**DAC 25/07/23 – 21 PARNELL PLACE NEWCASTLE EAST –
DA2022/00705 – MIXED USE - ALTERATIONS AND ADDITIONS TO
EXISTING HOTEL OR MOTEL ACCOMMODATION (NEWCASTLE
BEACH HOTEL), ANCILLARY FOOD AND DRINK PREMISES AND
COMMERCIAL USE (ANCILLARY HOTEL SPA) AND DUAL
OCCUPANCY (ATTACHED 2 X DWELLINGS)**

PARNELL PLACE

21 Parnell Place, Newcastle East, NSW 2300
LOT 1 /DP815595

DRAWING
EXISTING VS PROPOSED
ANALYSIS

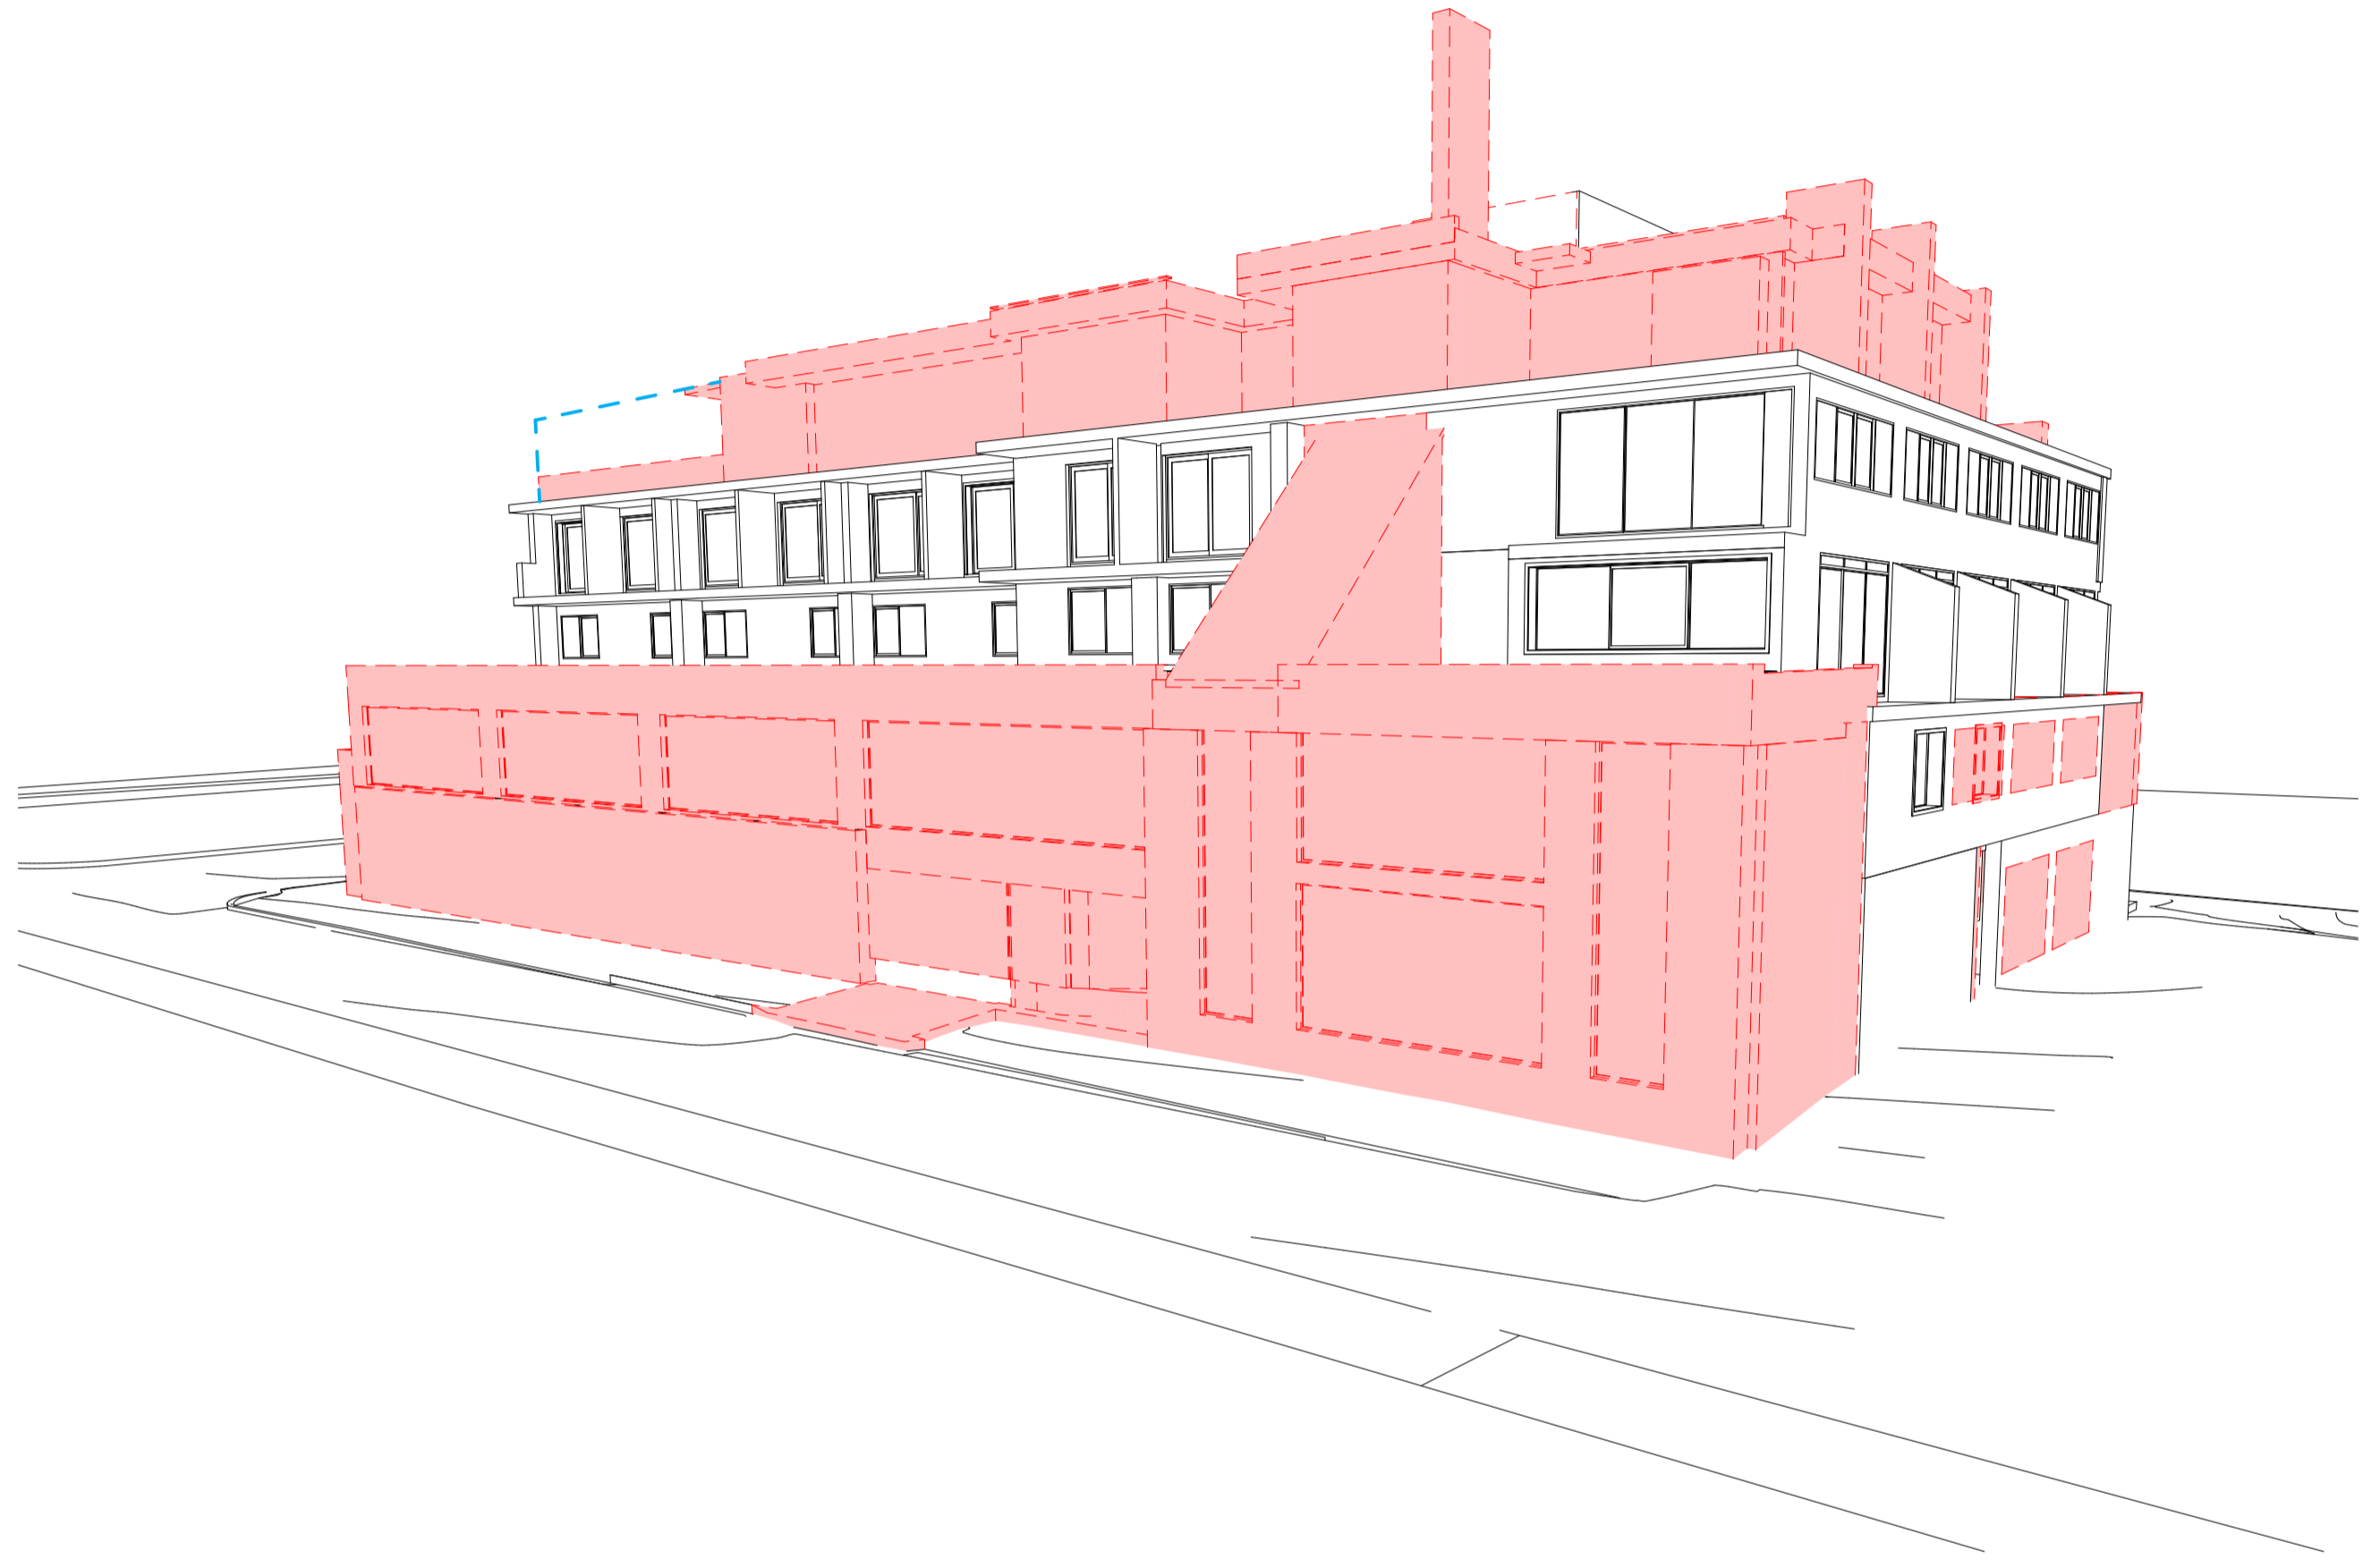
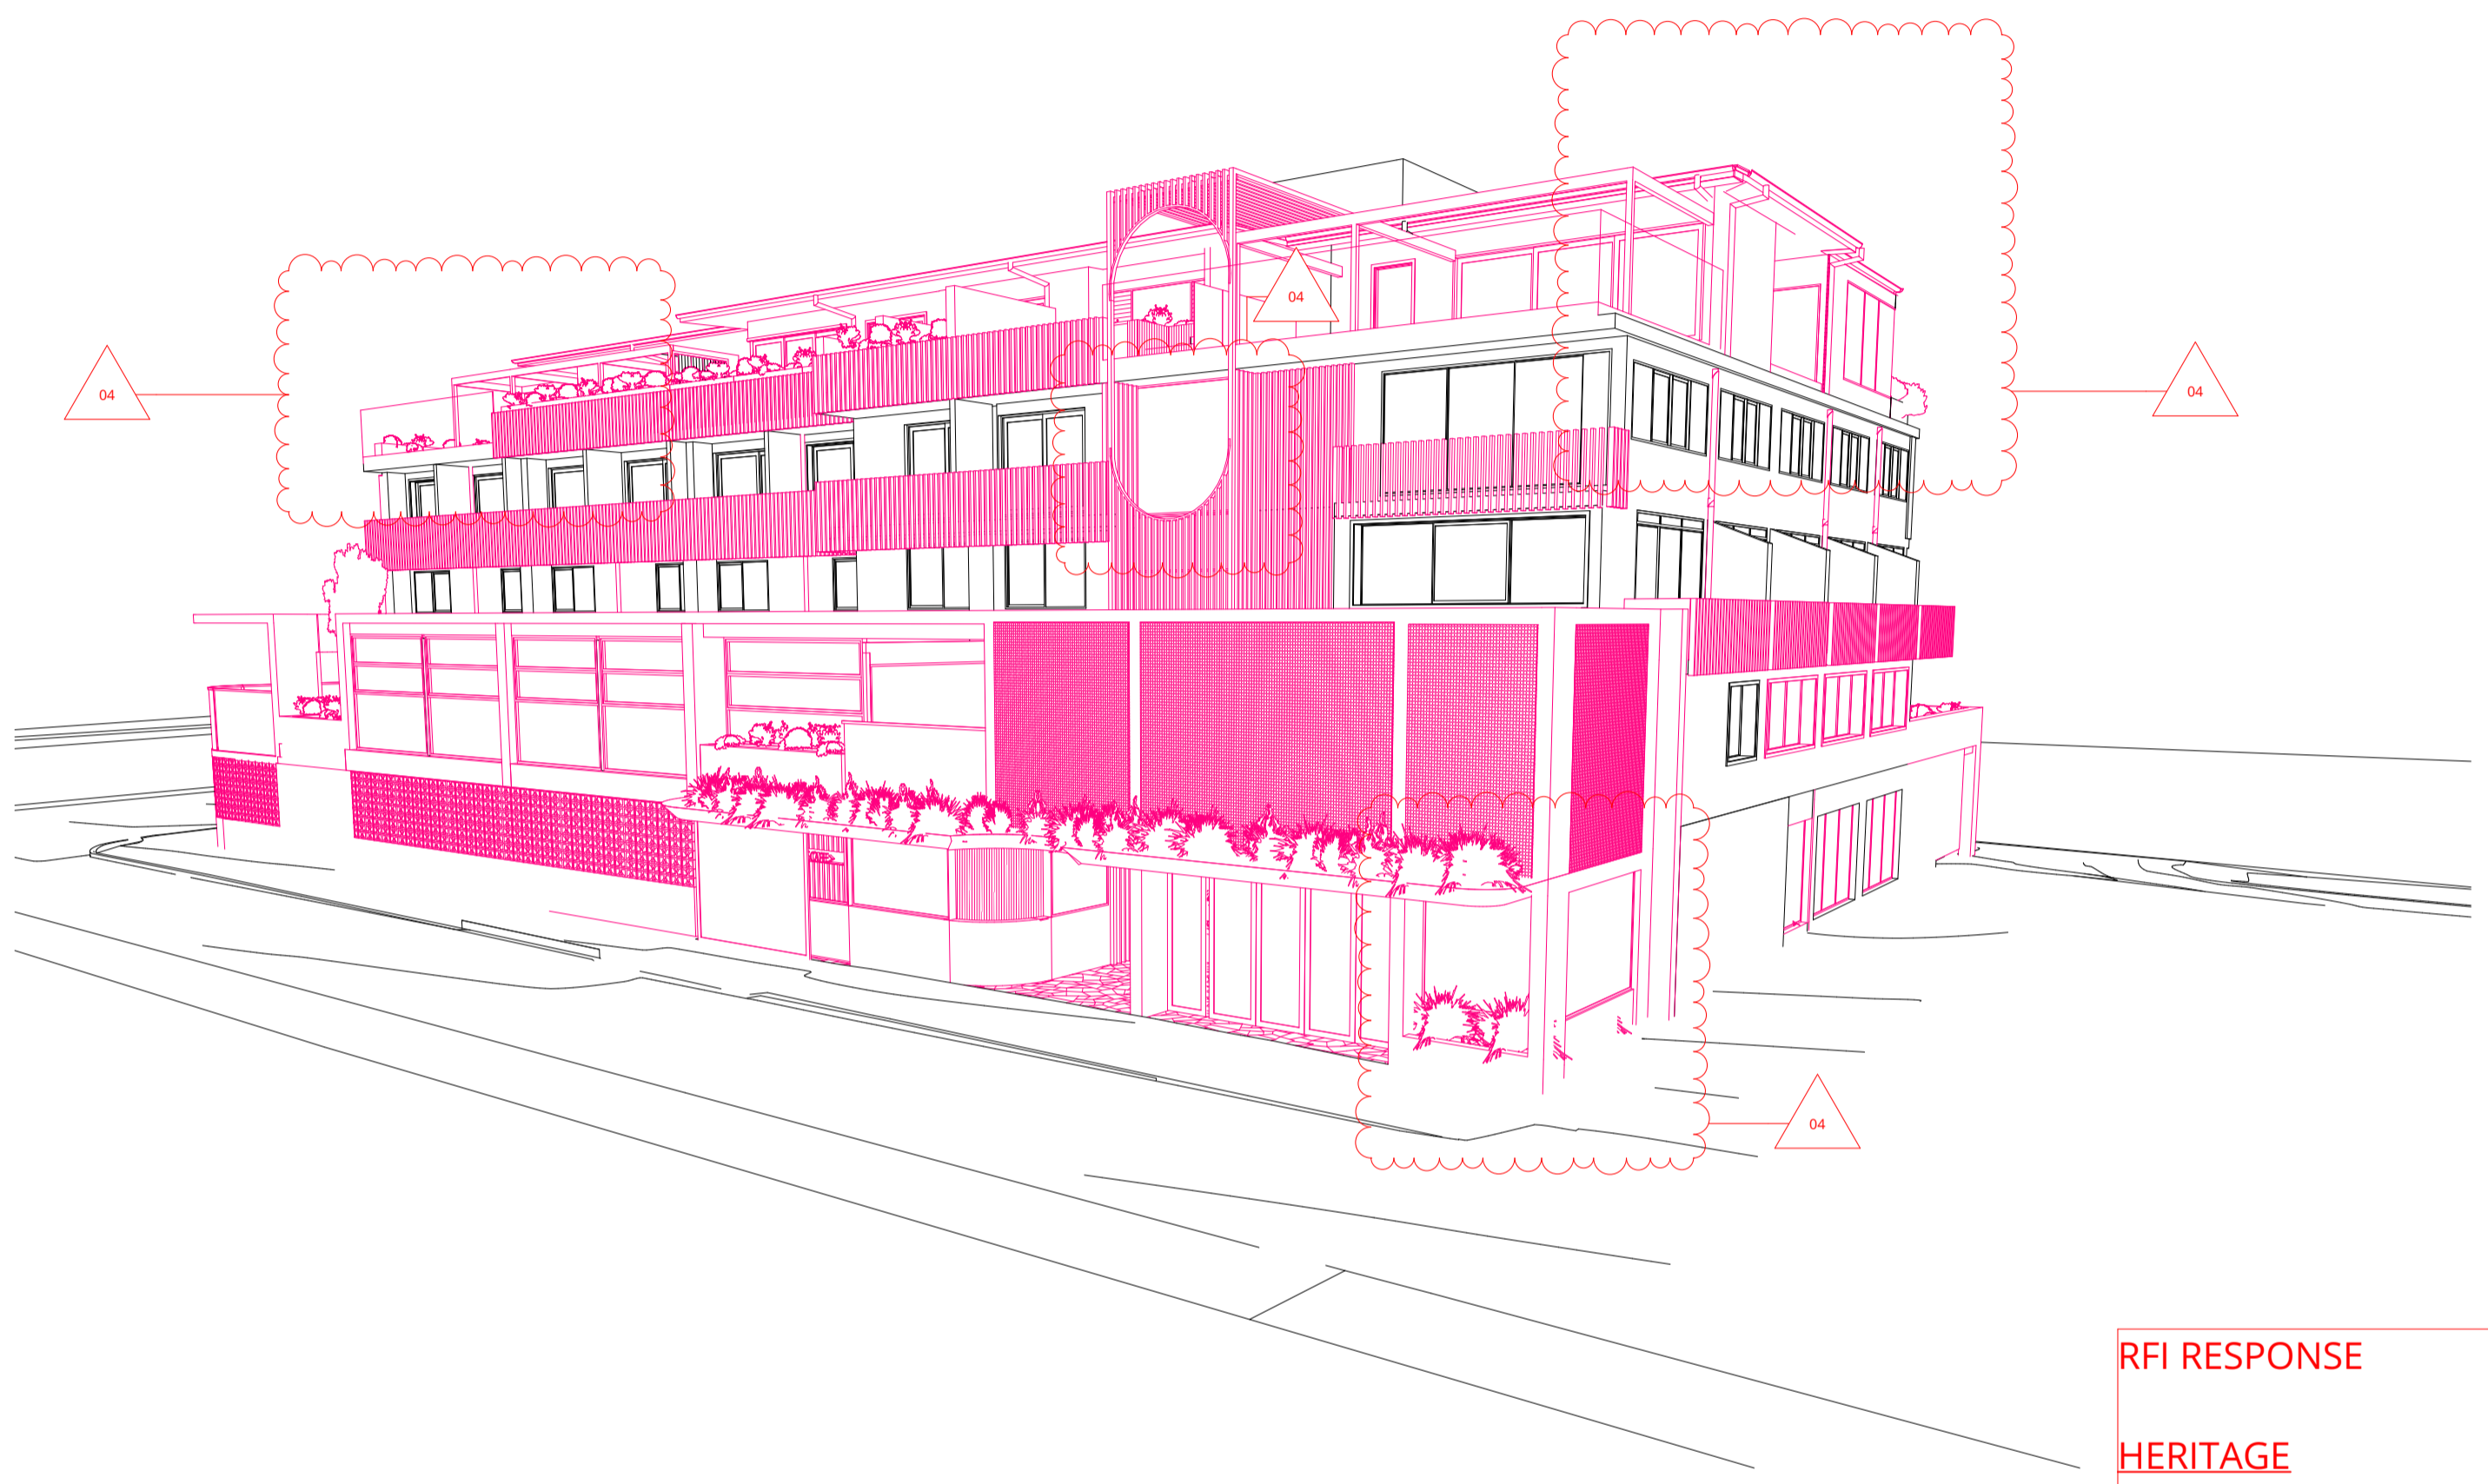
- PENTHOUSE 2 SETBACK FROM SOUTH EAST CORNER BY 1200MM AND LOW GARDEN ADDED TO SOFTEN EDGE AND REDUCE BULK & SCALE
- PENTHOUSE 2 MOVED 600MM TO WEST TO MAINTAIN FLOOR AREA
- PENTHOUSE 2 EAVE REDUCED BY 600MM TO REDUCE SCALE
- ADDITIONAL LANDSCAPING TO PENTHOUSE 01 NORTH-WEST CORNER
- LEVEL 03 SIGNAGE ZONE REMOVED

1 BASEMENT FLOOR PLAN
 SCALE 1:100

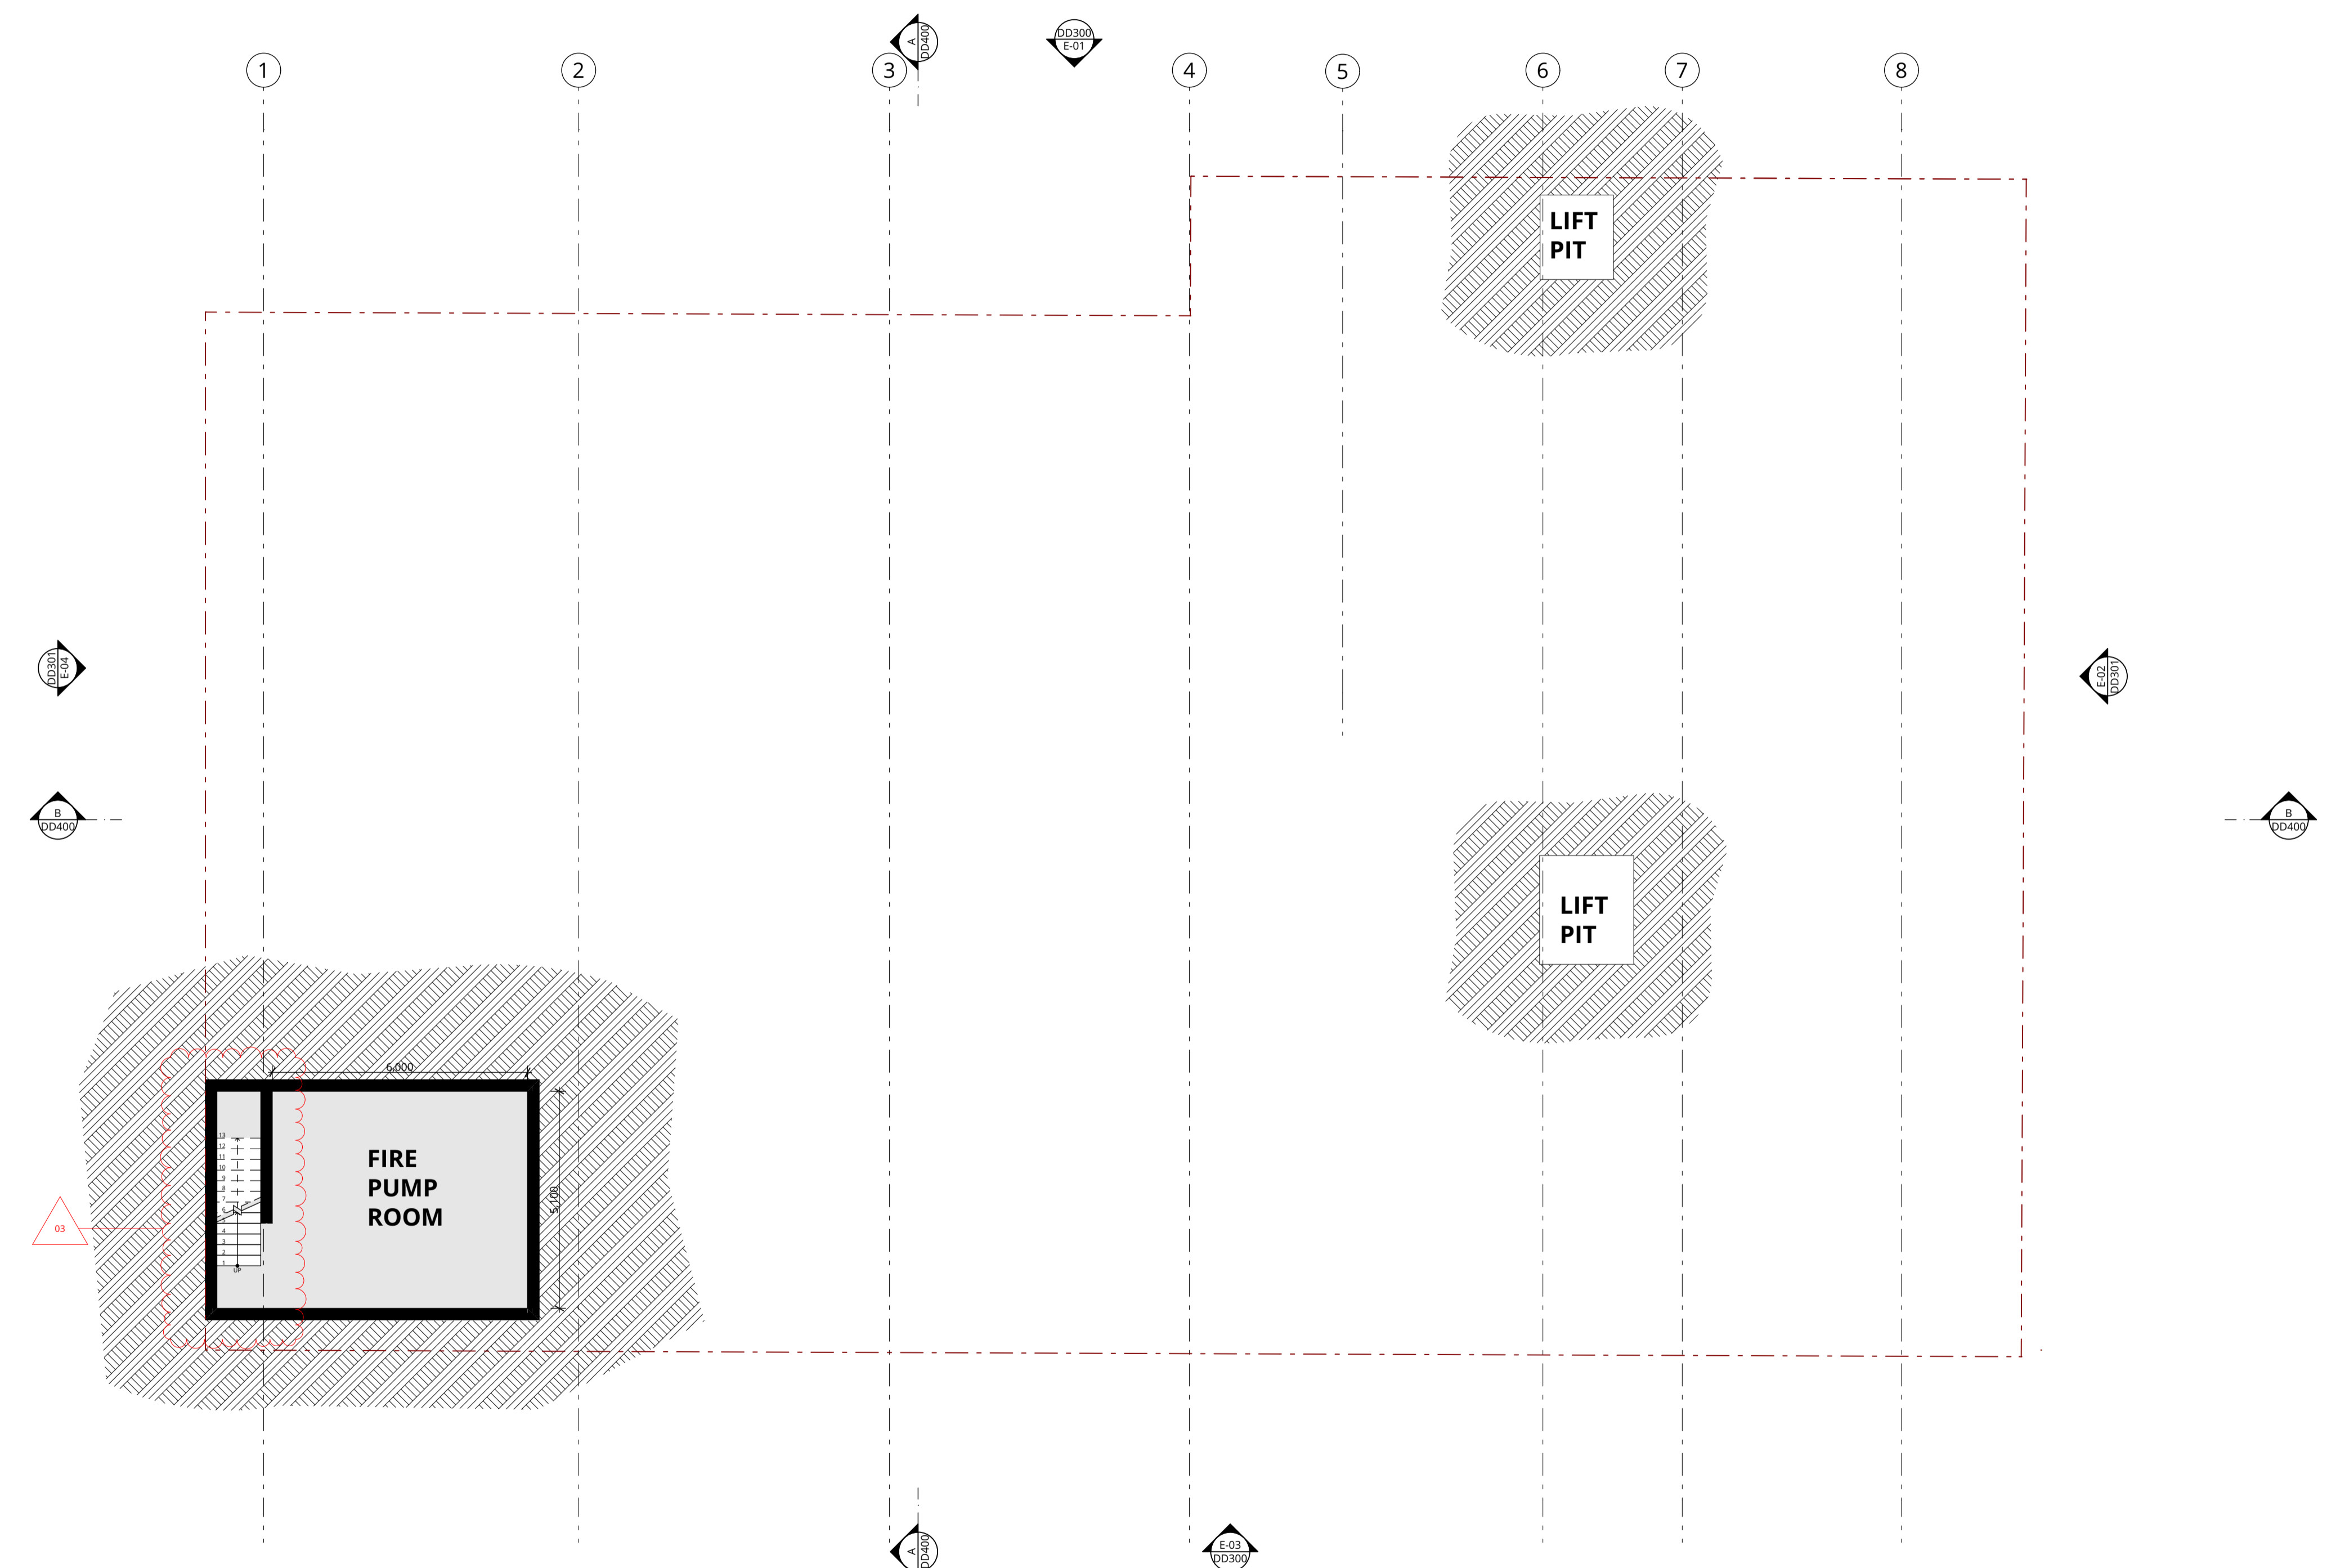
RFI RESPONSE - 13/10/22 & 14/11/22
 - STAIR MOVED TO ALLOW FOR SIGHT
 LINES ABOVE IN CARPARK/ EXIT DOOR
 JUNCTION
